AMENDMENTS TO THE DRAWINGS:

REMARKS

This amendment is responsive to the Office Action dated April 10, 2006. Claims 1 - 25 are pending in the application. Claims 10 - 12 and 14 - 25 have been withdrawn from consideration. Claims 1 - 9 and 13 have been examined and have been rejected. Reexamination is respectfully requested in light of the foregoing amendments and following remarks.

FIG. 12

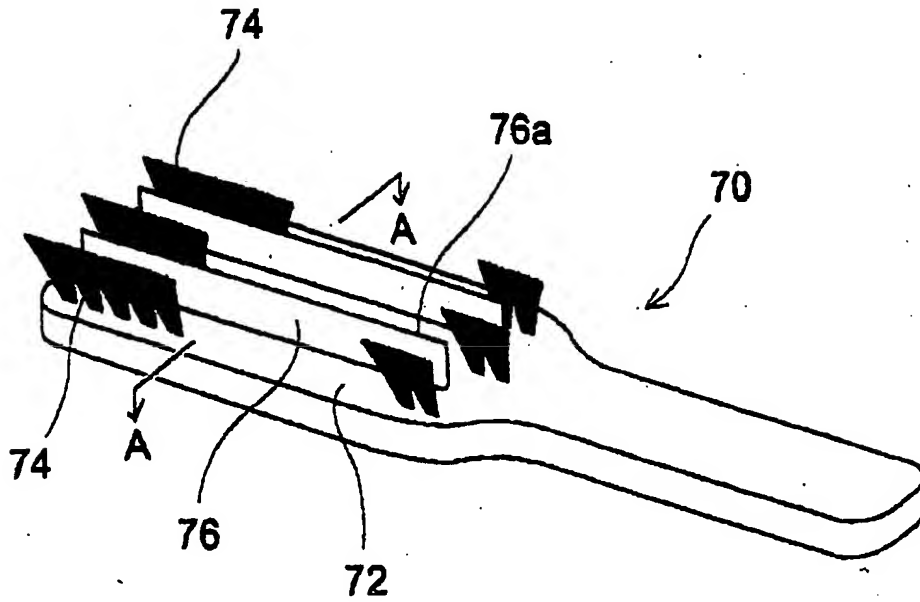
In Figure 12, the legend Prior Art has been added.

PRIOR ART

FIG. 13

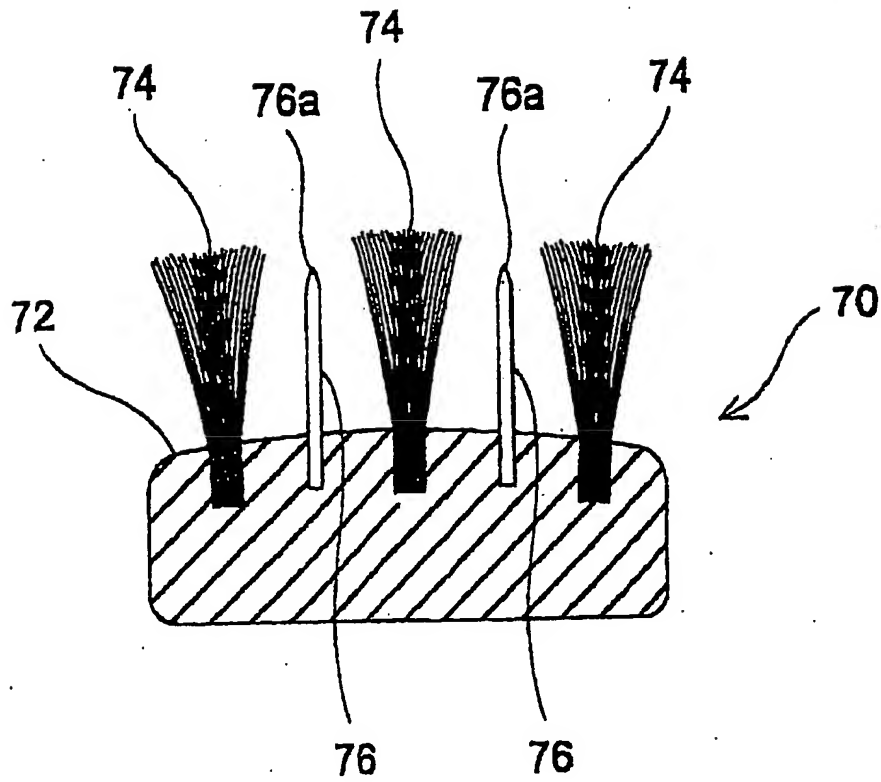
In Figure 13, the legend Prior Art has been added.

PRIOR ART
